| Project Title: | Great Oaks South Backup Generating Facility Small Power Plant Exemption |
| Document Title: | Great Oaks South intervenor Sarvey's Reply Testimony |

Intervenor Sarvey's Reply Testimony

Figure 1: Land Use Plan

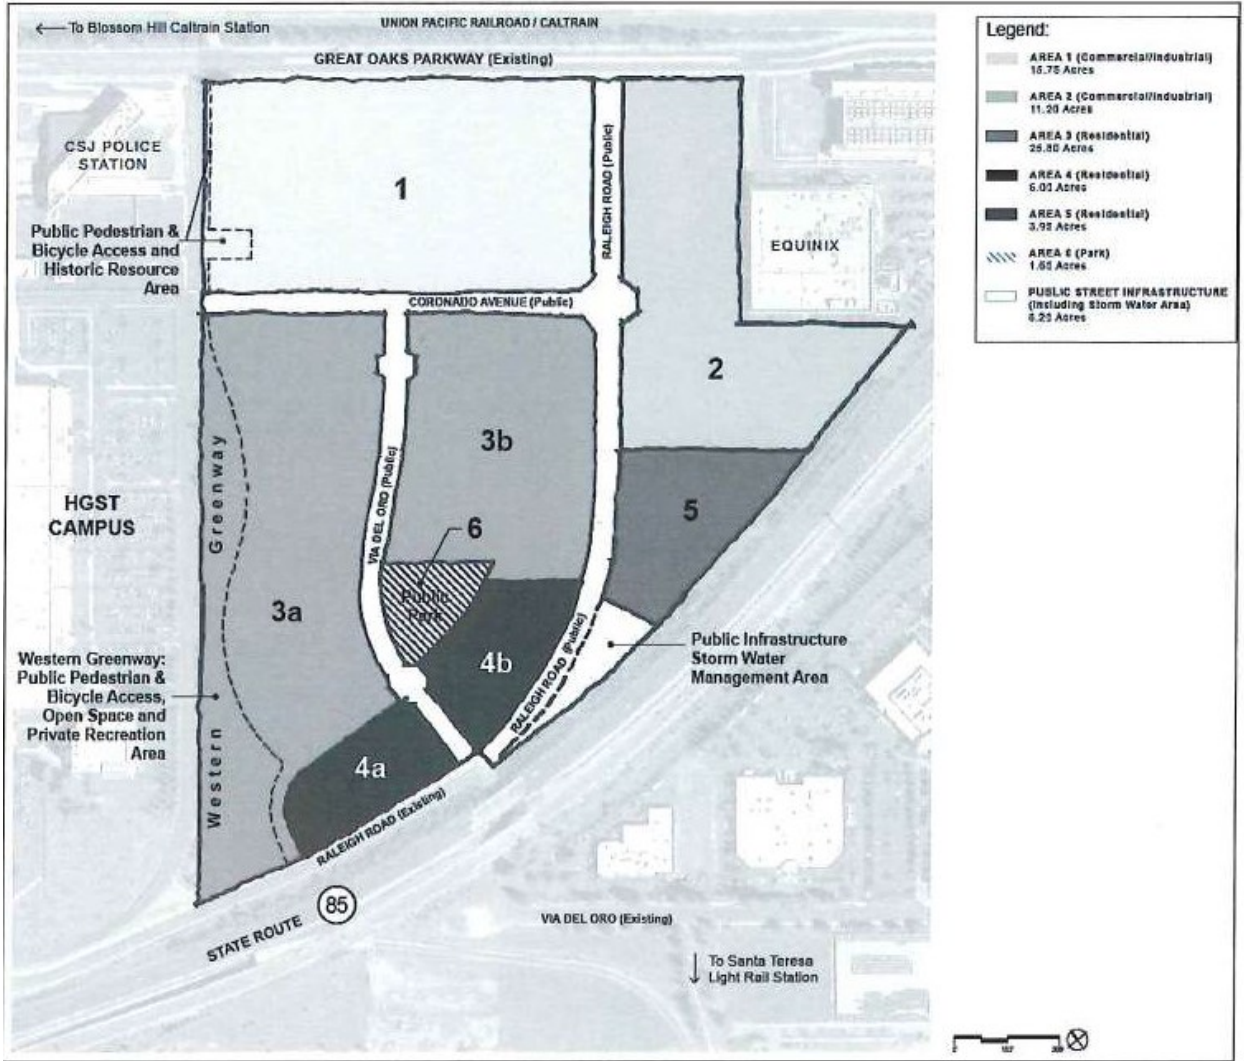
The Staff and applicants' analysis does not consider that the Equinix Data Center is part of a larger development the Great Oaks Mixed Use Project which received its Final Environmental Impact Report (adopted November 18, 2014 by Council Resolution No. 77219).¹ The entire project does not seem to be considered anywhere in any analysis. According to the projects addendum the project includes up to 720 residential units and 154,000 square feet of commercial uses.² Impacts to the residents of the approved residential and commercial development are apparently never considered for noise and air quality impacts.
